CS Memorandum No. 1324

To: Distribution
From: Susan MacKenzie, Document Control Manager 
Date: January 2, 2013
Reference: Project No. M544.1, Contract No. CS-149
Task No. 1-8.02, Change Control
Subject: Configuration Management Board Meeting No. 105

SUBJECT: Configuration Management Board Meeting # 105 – Rev. No. 0

\\s6nos003\m544.1\FinalDesign\Drawing-821\2-Civil\Utility Demolition\Sheet Files CP03\M54423UD403_R1C.dwg fbayani Thu Aug 25, 2011 - 9:21 am UD-403_R1C

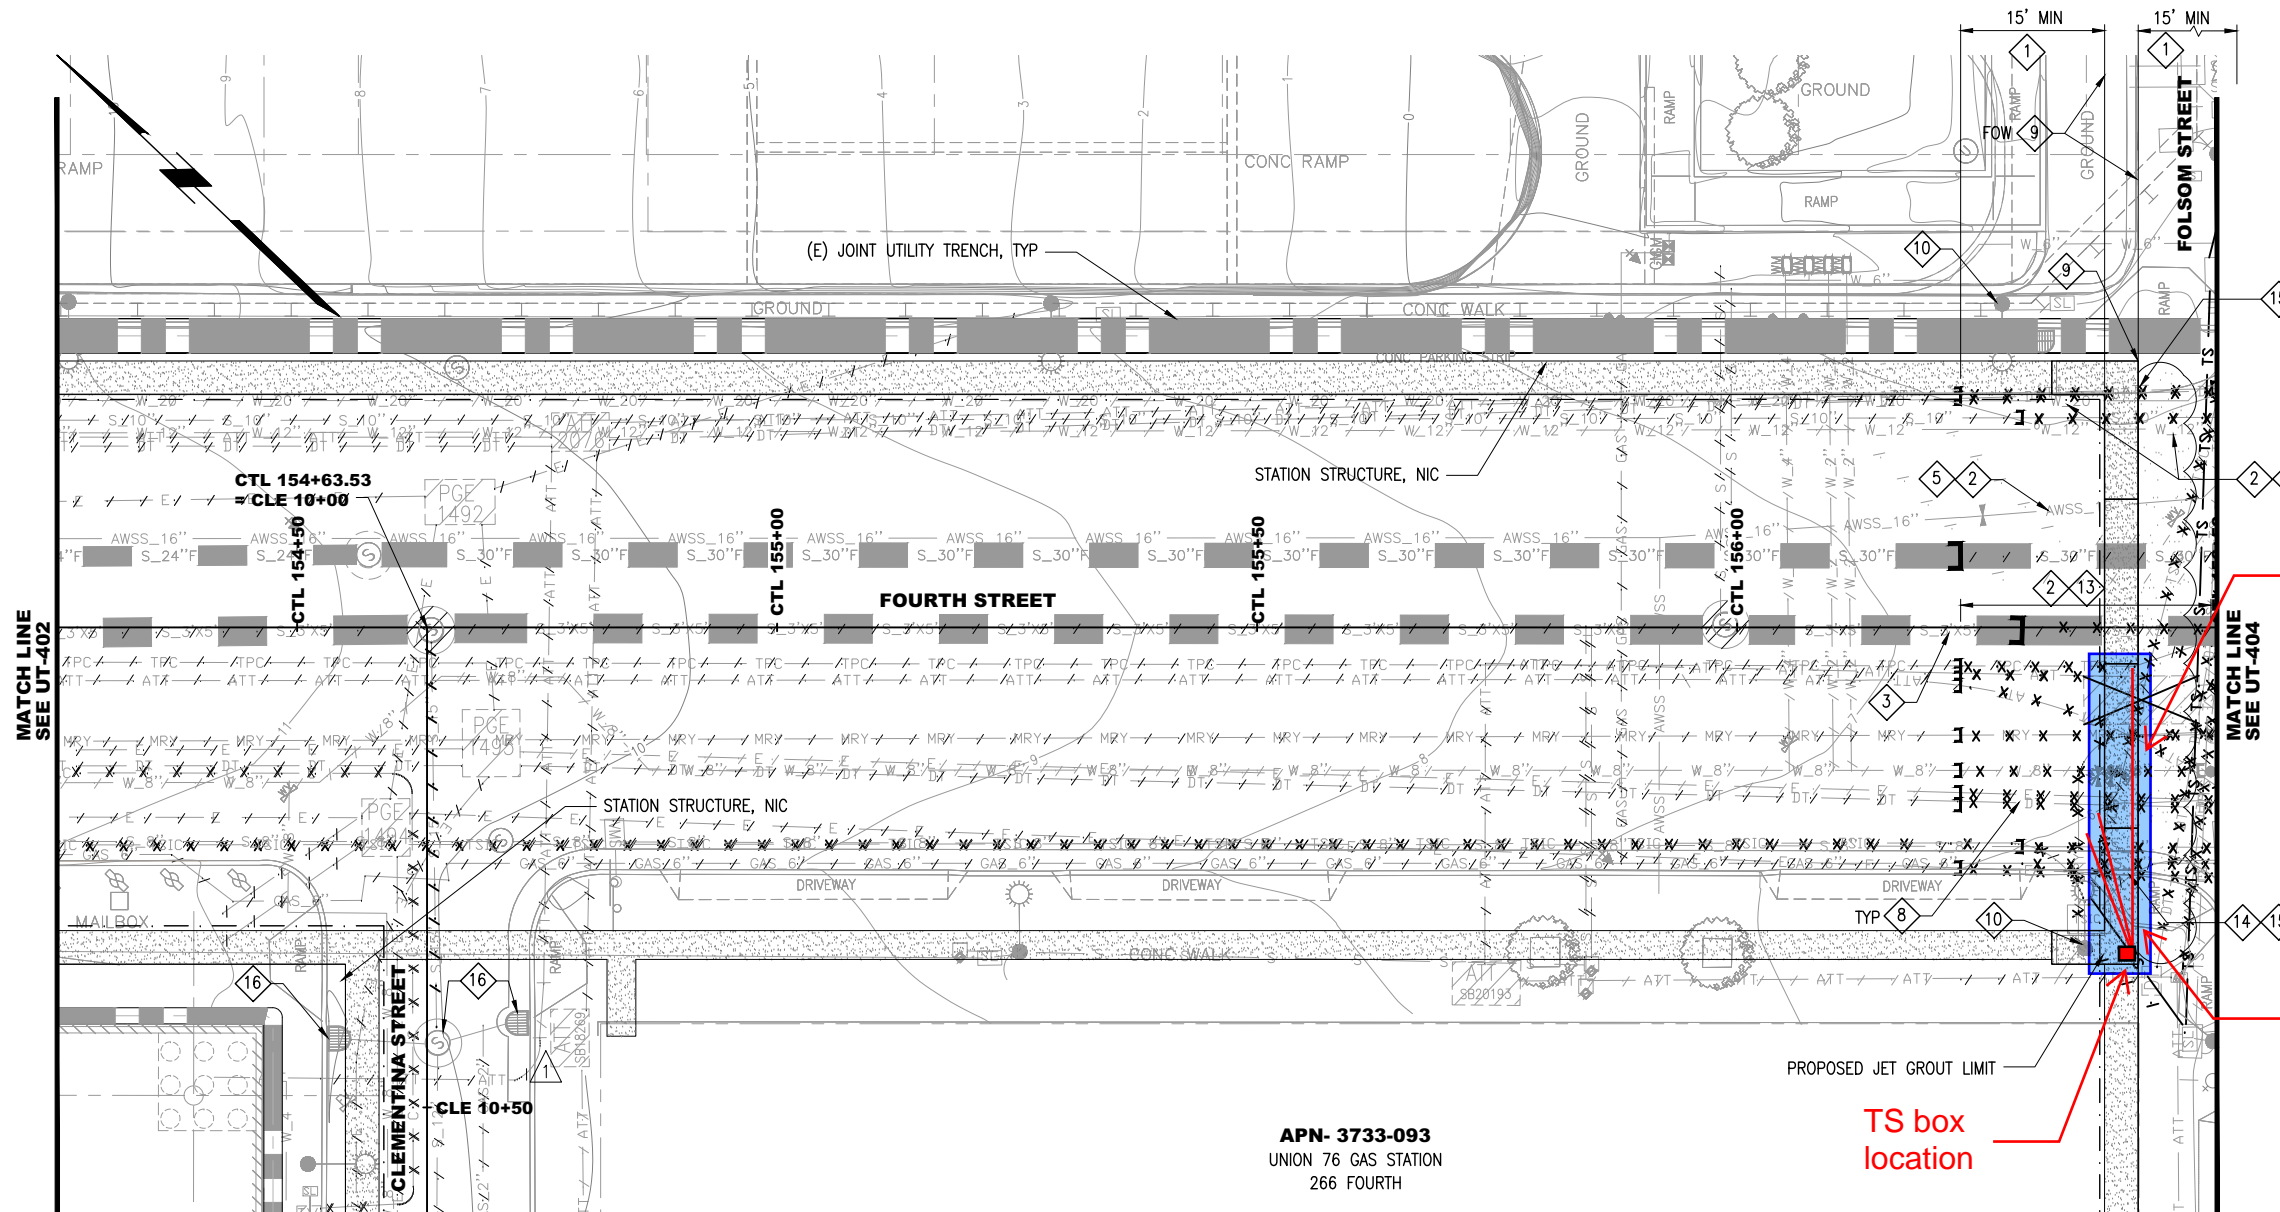
Facts: During utility demolition excavation at the Moscone south headwall BIH's subcontractor, Synergy Project Management (SPM) discovered three existing live traffic signal conduits which ran lengthwise across the planned headwall. Drawing UD-403, Rev. 1 shows the existence of one live traffic signal line which crosses the southwest corner of the headwall and another live traffic signal line approximately 5' to 6' south of the headwall. The drawing requires that BIH maintain active utilities so these lines would need to be protected in place during construction.

Technical direction was provided on July 6, four days after receipt of the RFI related to this work to permanently re-route the traffic signal lines across the north leg of the intersection at Fourth and Bryant St. On July 7th SPM commenced traffic signal relocation and by August 2nd, 2012 the work was completed.

\\Sofra003\ym6441\Final\Design\Drawing-821\2-Civil\Utility Demolition\Sheet Files CP03\M54423\UD402.dwg FBoyant Wed Jan 26, 2011 - 1:57 pm UD-402

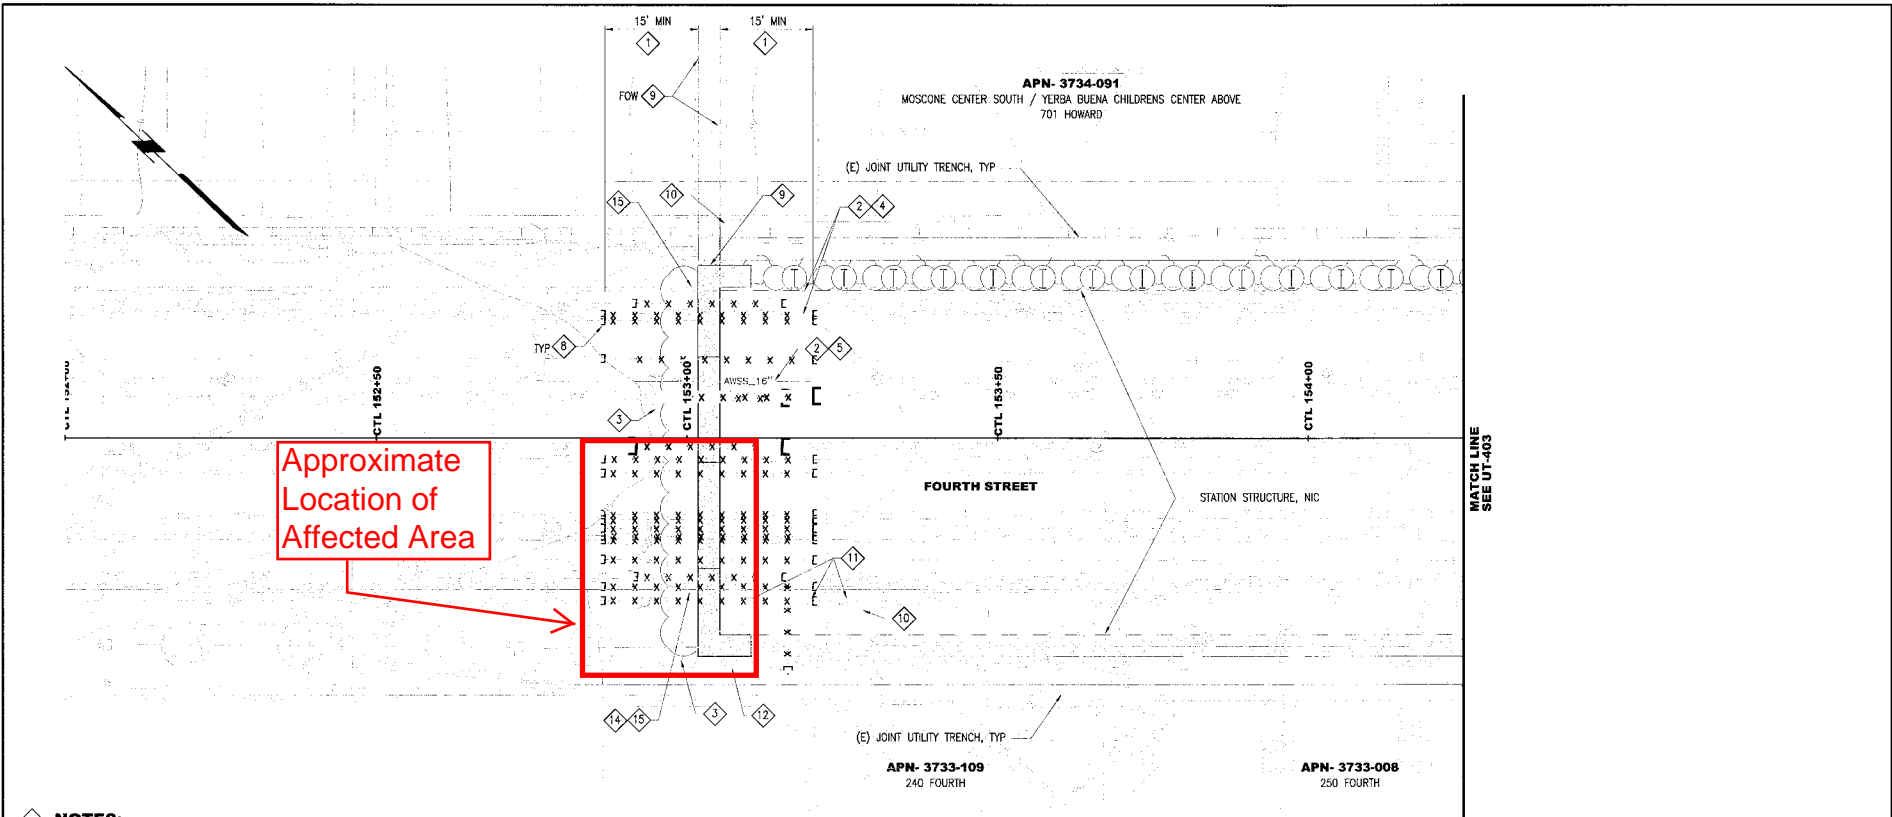
Facts: On July 2nd, 2012, while excavating for guidewalls at the Moscone north headwall the Contractor discovered archaeological artifacts within the excavation area. The Contractor immediately notified the Engineer. The Program's Archaeologist, with concurrence of the Environmental Review Officer (ERO), implemented a modified process based on the Archaeological Testing Plan (ATP) for Moscone Station, to specifically address trenching conditions. The modified process involved bagging midden, moving to available area at the work site so that guidewall excavation could continue, screening a sample of the midden at site, confirming no new or additional artifacts were found, and disposing of midden at the site with other excavation.

The Contractor's crew was requested by SFMTA to provide support to the Archaeological team for excavation and safe handling of the material. By July 6th, 2012 work or impacts associated with this discovery had been completed. A time extension has not been requested for this work.

SHEET
EL-01

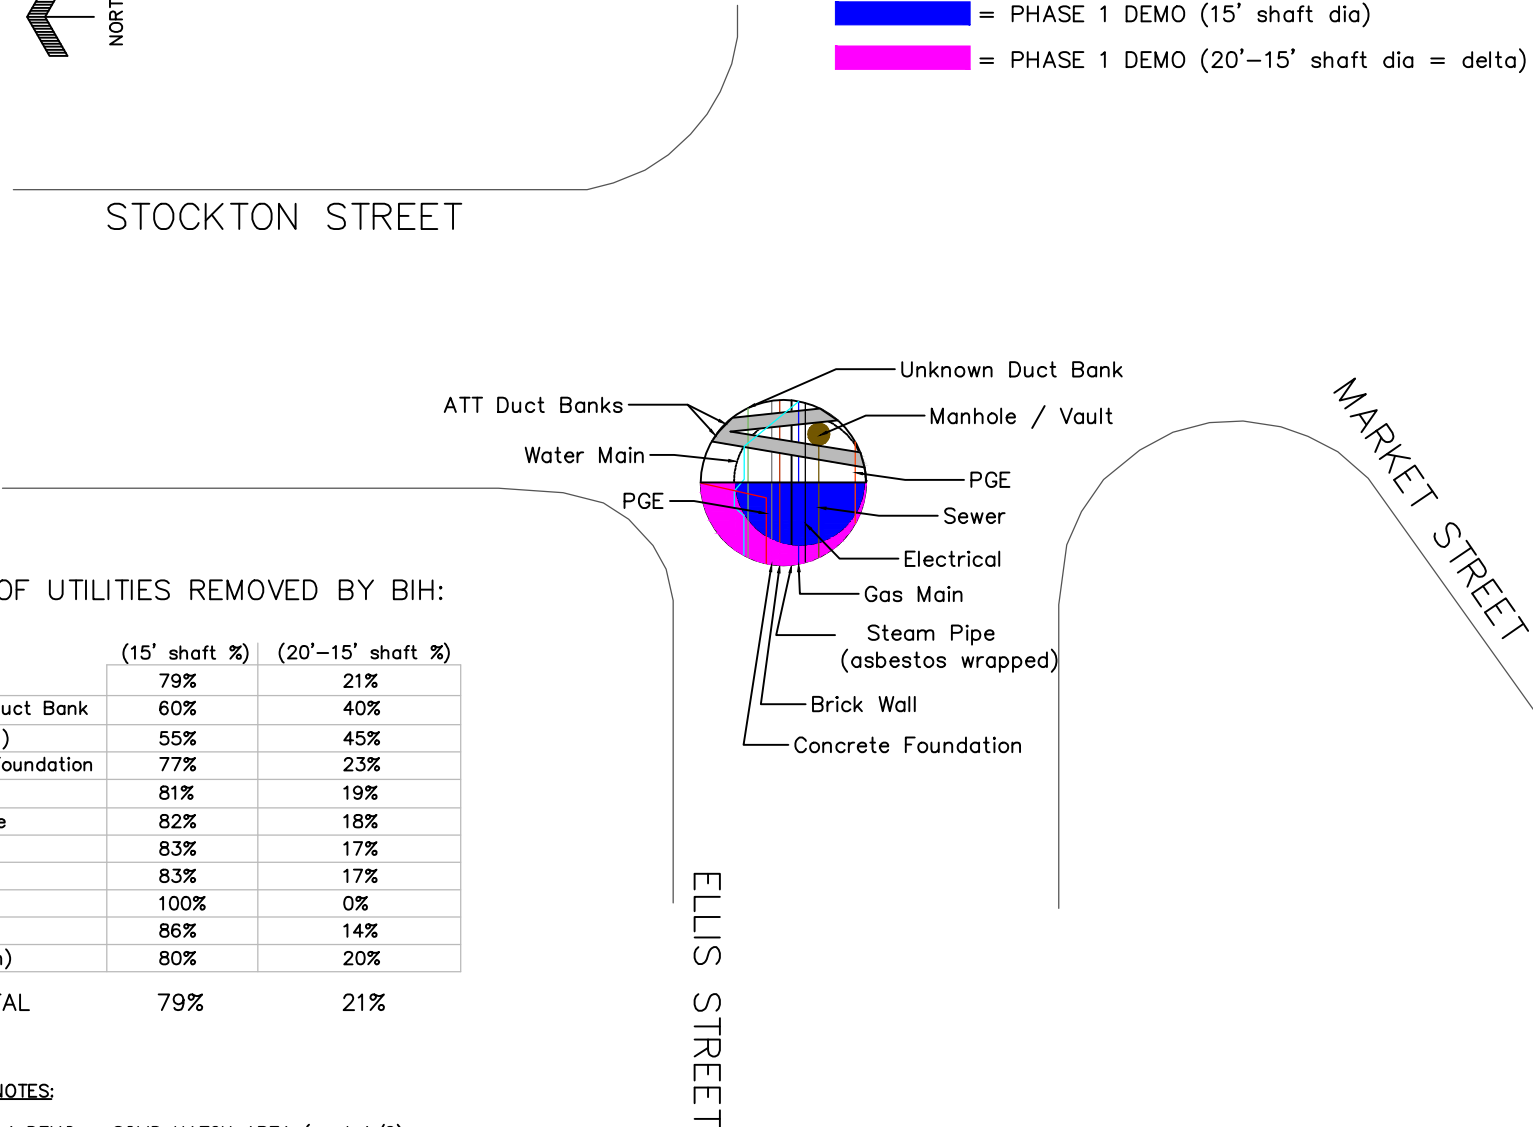
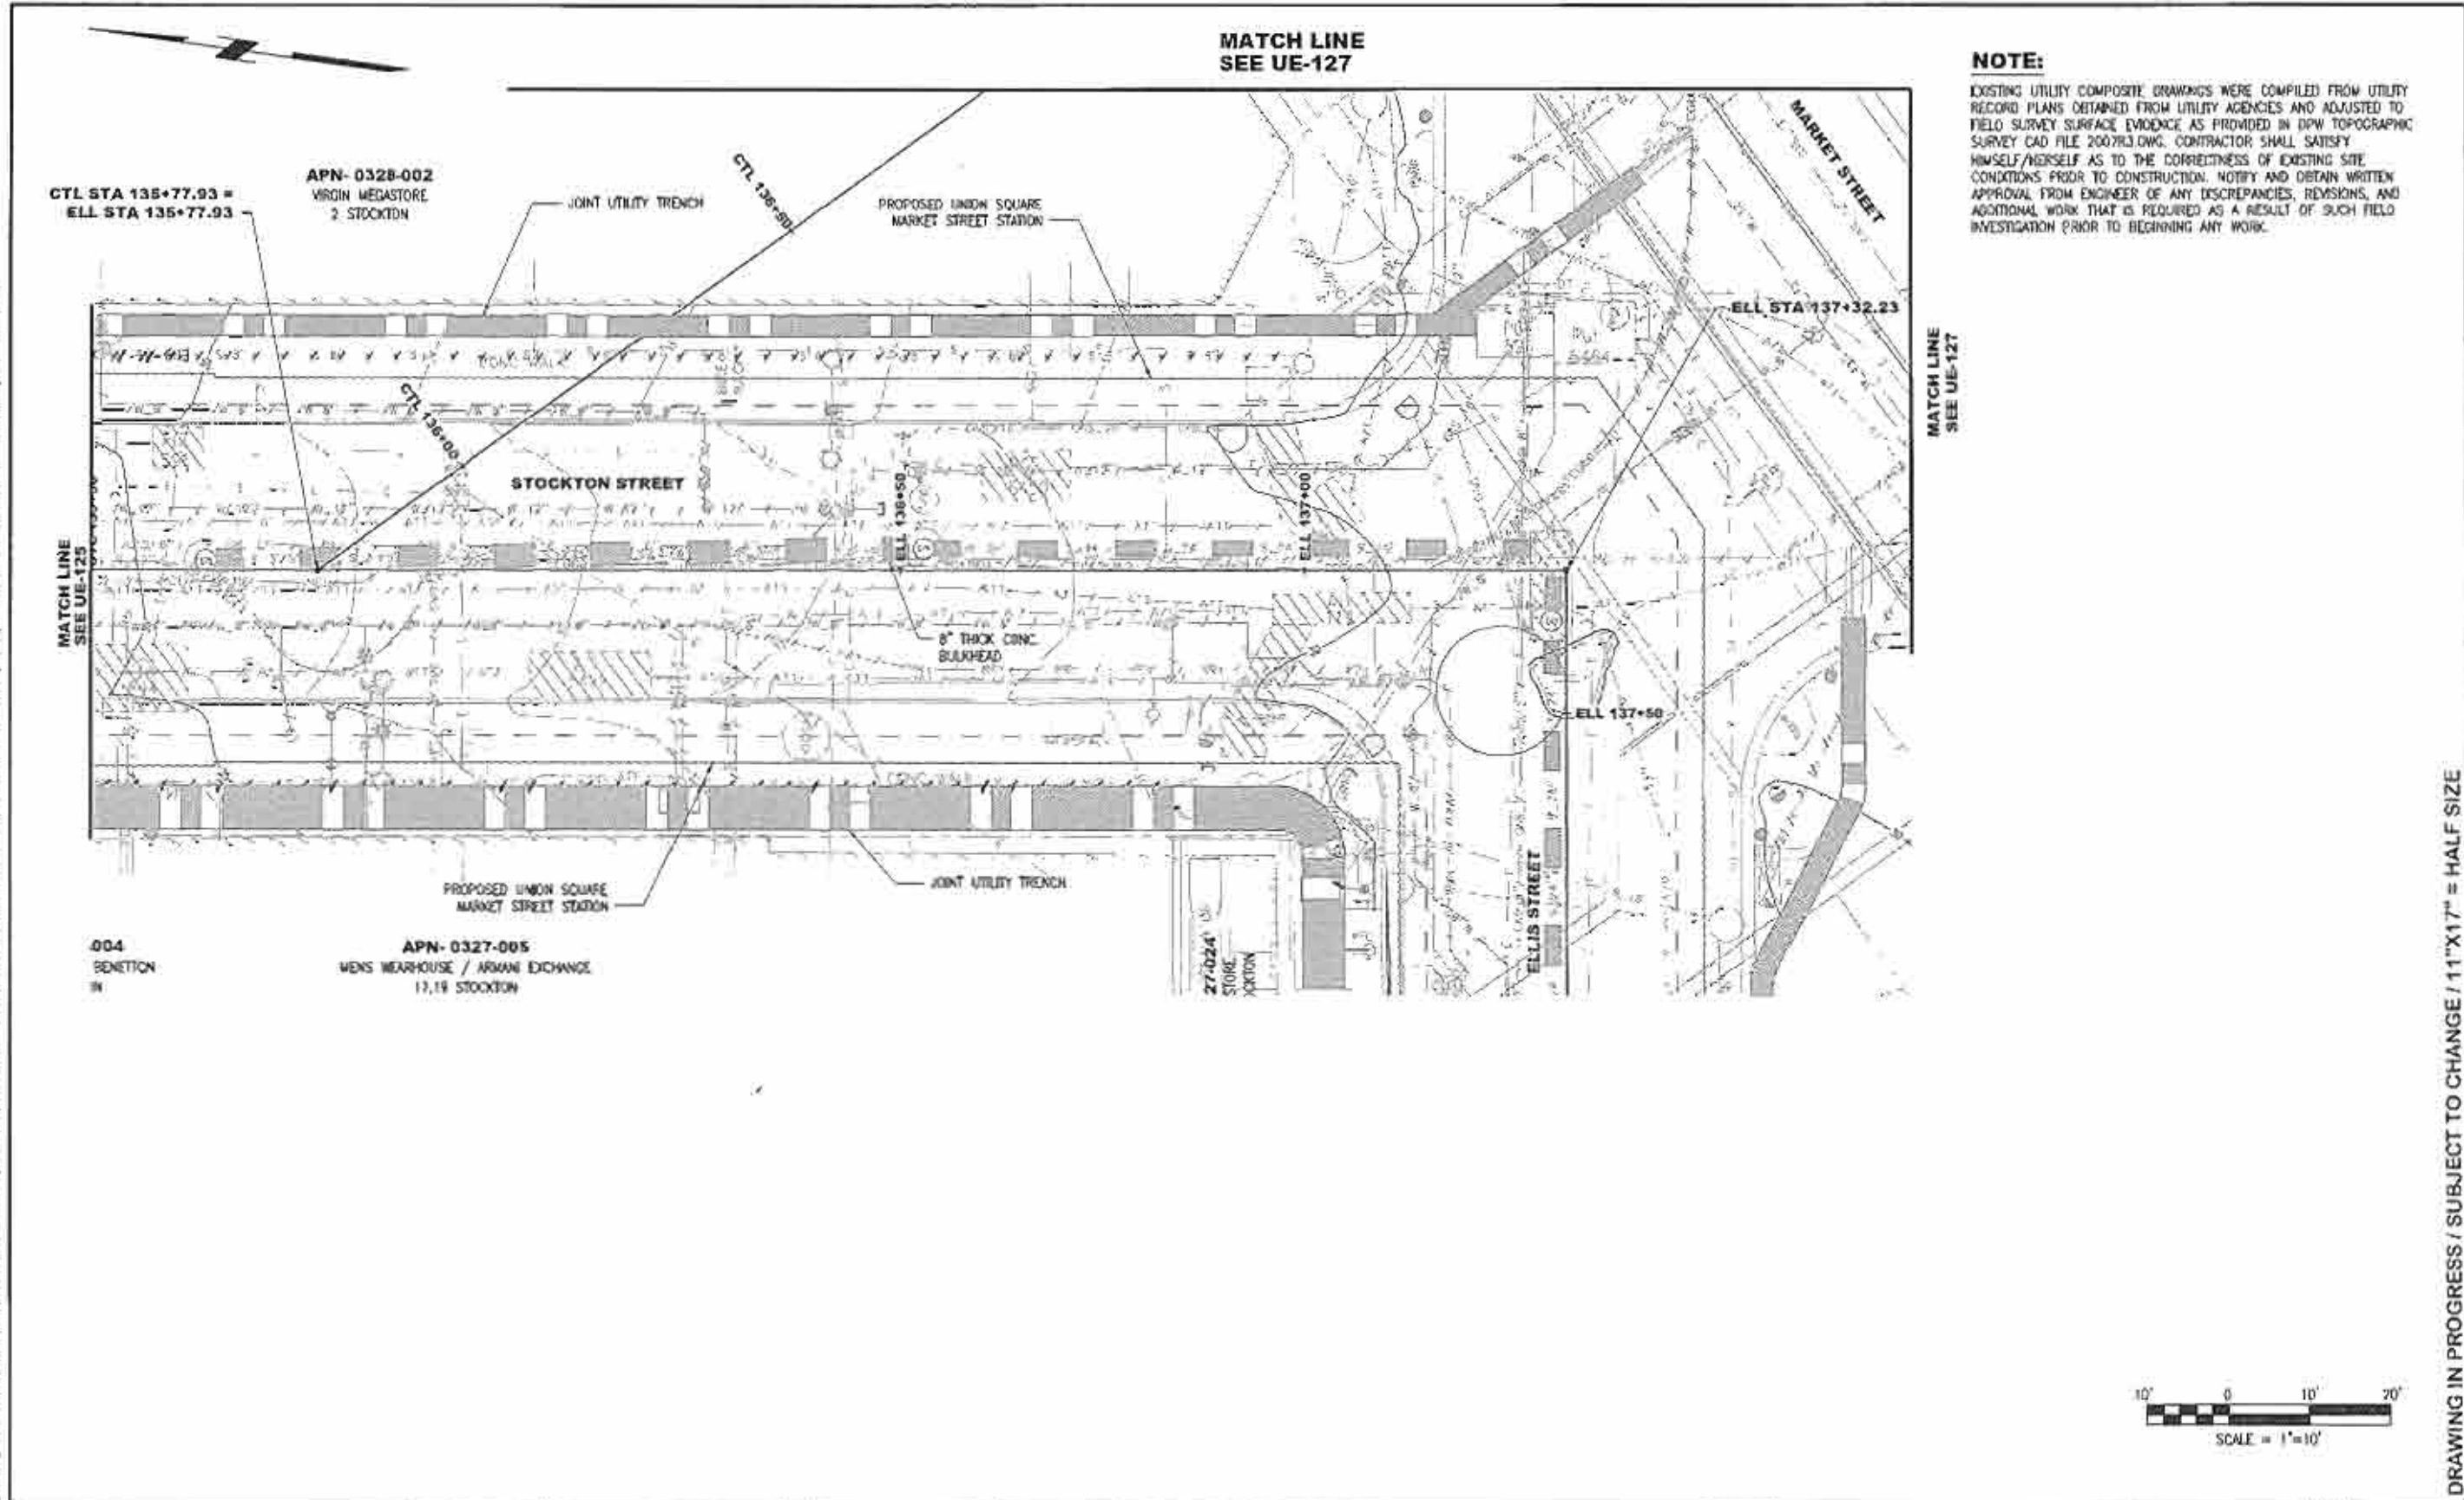
Facts: The Contractor discovered utilities at the Ellis shaft location that were not indicated on the utility demolition and utility composite drawings included in the contract drawings. The Contractor notified SFMTA of the utility conflicts on August 2nd, 2012 in Letter No.05 indicating that they would remove the utilities prior to submission of a COR. The Contractor has completed the removal of utilities at the Ellis shaft location. The Contractor did not submit a request for time extension.

Justification: The RE finds no Merit for removal of utilities shown on the Existing Utility Composite reference drawing UE-126 to cross the Ellis Shaft construction limits. This includes a sewer vault as well as low voltage electrical, sewer and gas utilities. The reference drawings were part of the contract documents made available to Bidders prior to the deadline for submitting bids. Additionally, no Merit shall be given for potholing as verifying the location of existing utilities is incidental to the work.

The RE finds Merit for removal of utilities not shown or indicated on the Existing Utility Composite reference drawing UE-126 to be outside the Ellis Shaft construction limits. This includes a 8" water main, an unknown duct bank, concrete foundation and brick wall, steam pipe and sewer manhole.
